ADDENDUM NO. 2

Date: January 16, 2024

**Project: Project #: 0510-470
C.K. McClatchy High School New Softball Field and Baseball Field
Improvements**

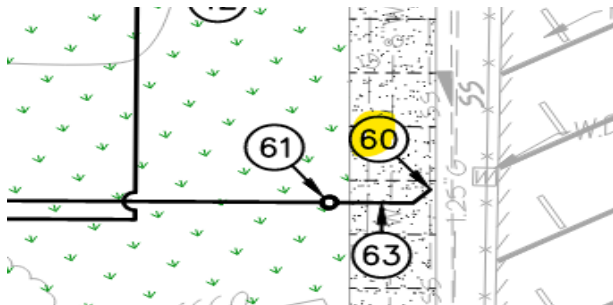
QUESTION #13: Please provide dimensions for the wall footing at dugout per detail 12/S401.

RESPONSE: Footing is tagged as FC4.5 on Enlarged Plan 4/ SS-401. Per the footing schedule it is 4.5’ wide x 2.0’ deep with (5) #5 continuous bars top and bottom w/ #4 ties spaced at 16” on center.
